**ADDENDUM NO. 5**

**September 6, 2023**

**RE: Grant County Extension Office  
105 Banton Rouge Road  
Williamstown, Kentucky 41097  
Project No. 20026**

1 ELECTRICAL SITE PLAN  
E-001 SCALE: 1" = 20'-0"

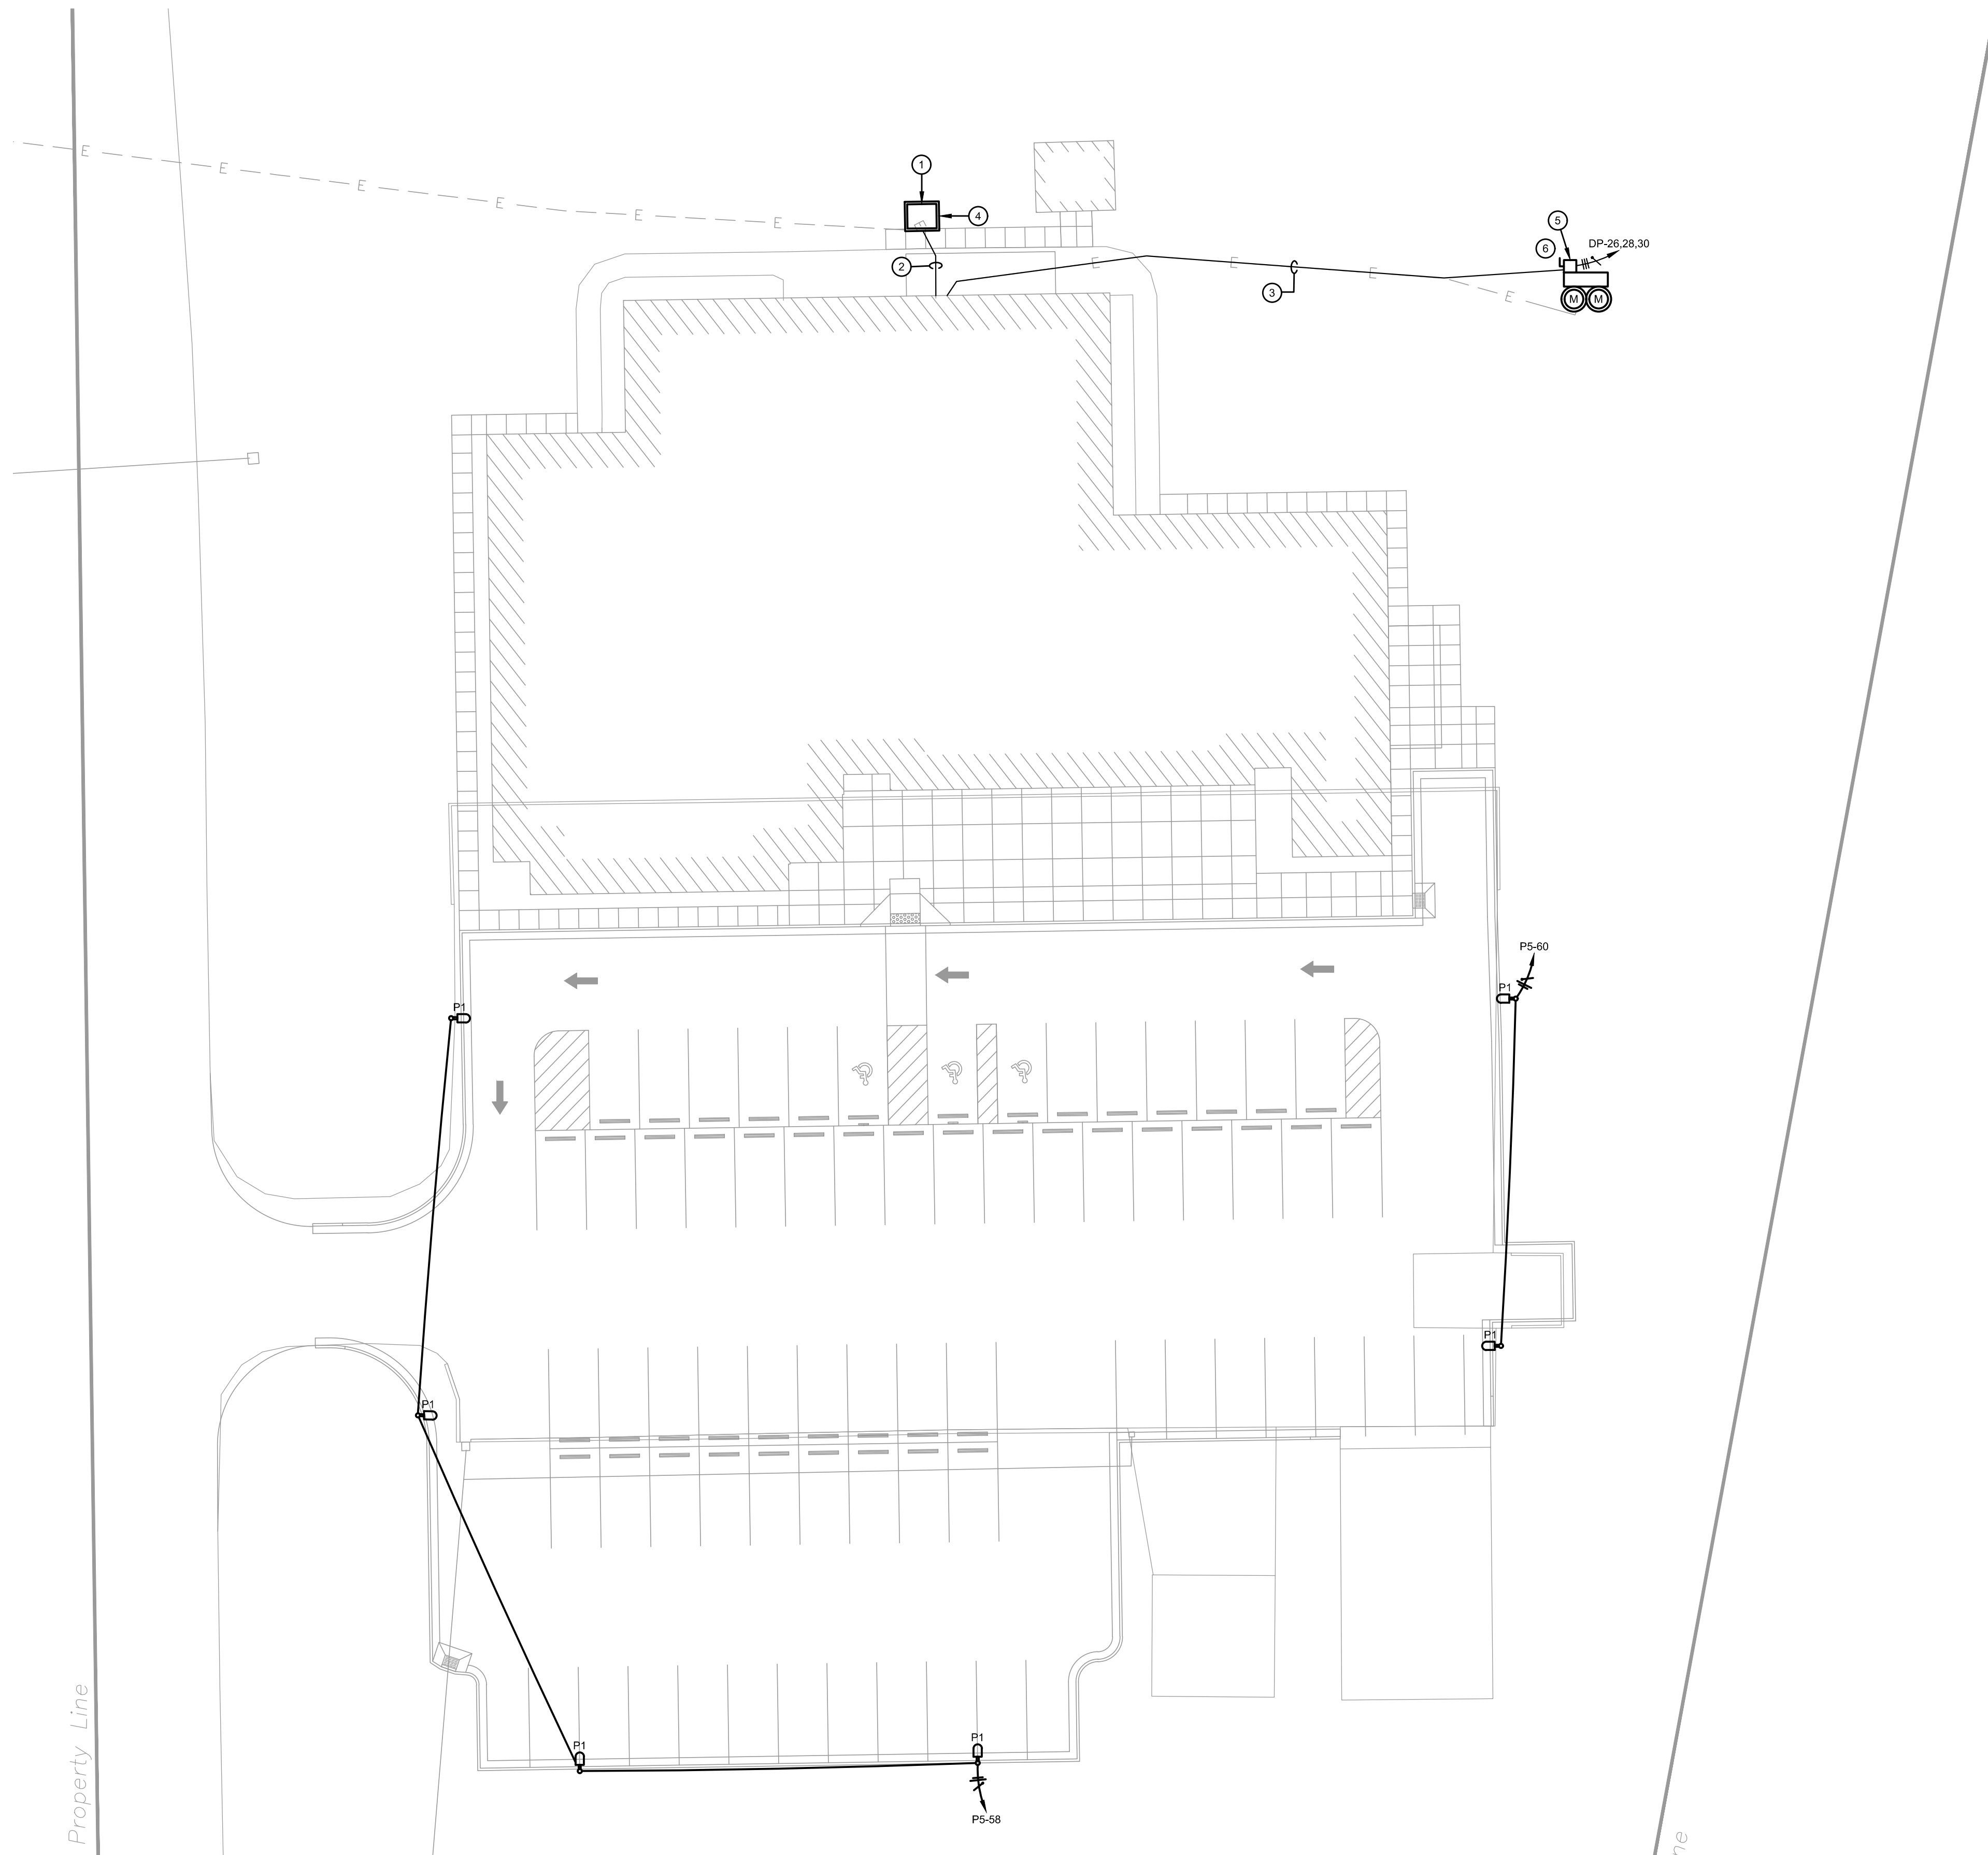
1. E-001 – Electrical Site Plan
  - a. Refer to full size sheet E-001 Electrical Site Plan.
